dsPIC33CH128MP508 Family Silicon Errata and Data Sheet Clarification

The dsPIC33CH128MP508 family devices that you have received conform functionally to the current Device Data Sheet (DS70005319D), except for the anomalies described in this document.

FIGURE 1: I/O RAMP

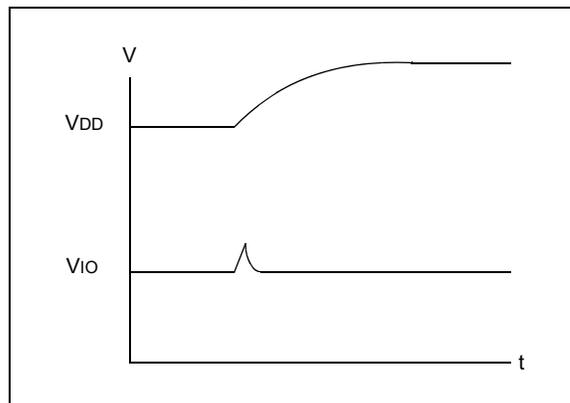
During a fast device power-up, when the V_{DD} ramp is less than 4 mS, the I/O pins may drive up to 100 μ A current for a duration of up to 10 μ S (Figure 1).

1. Slow down the V_{DD} ramp time (greater than 4 mS for V_{DD} to ramp 0V to 3.3V).
2. Ensure the circuitry that is connected to the pins can endure this pulse.

High-voltage applications with complementary switches should power the high-voltage 200 μ Sec later than powering the dsPIC[®] device to avoid the current shoot-through. This behavior is specific to each device and not affected by aging.

FIGURE 2-2: SUGGESTED PLACEMENT OF THE OSCILLATOR CIRCUIT

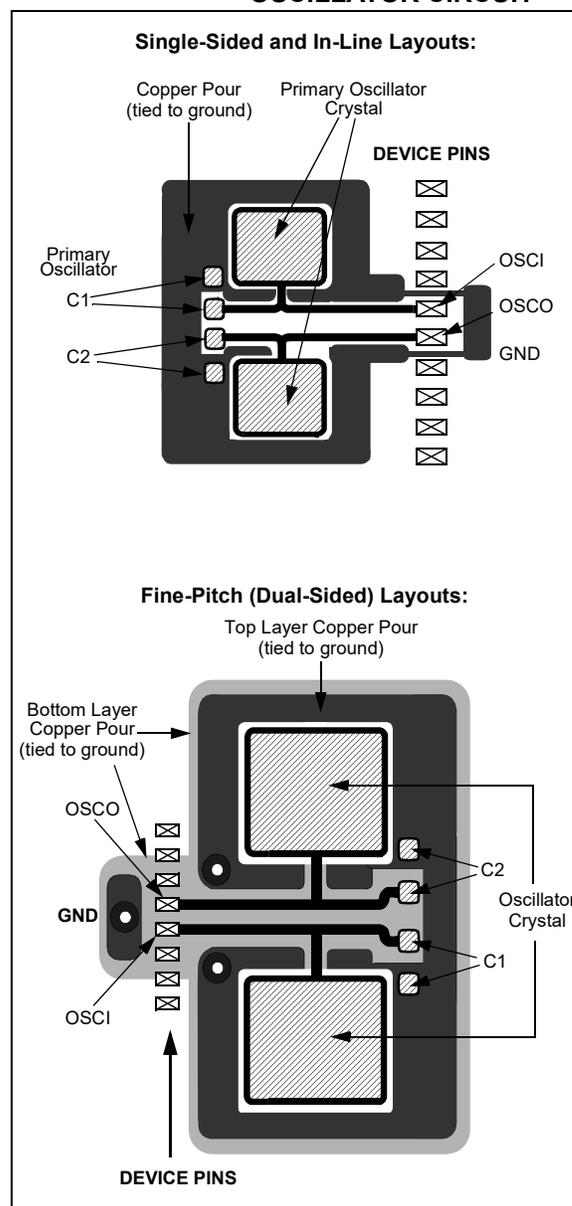
Additional information is added to [Section 2.5 “External Oscillator Pins”](#) and [Section 2.6 “External Oscillator Layout Guidance”](#) is added.

Use best practices during PCB layout to ensure robust start-up and operation. The oscillator circuit should be placed on the same side of the board as the device. Also, place the oscillator circuit close to the respective oscillator pins, not exceeding one-half inch (12 mm) distance between them. The load capacitors should be placed next to the oscillator itself, on the same side of the board. Use a grounded copper pour around the oscillator circuit to isolate it from surrounding circuits. The grounded copper pour should be routed directly to the MCU ground. Do not run any signal traces or power traces inside the ground pour. If using a two-sided board, avoid any traces on the other side of the board where the crystal is placed. Suggested layouts are shown in [Figure 2-2](#). With fine-pitch packages, it is not always possible to completely surround the pins and components. A suit-

able solution is to tie the broken guard sections to a mirrored ground layer. In all cases, the guard trace(s) must be returned to ground.
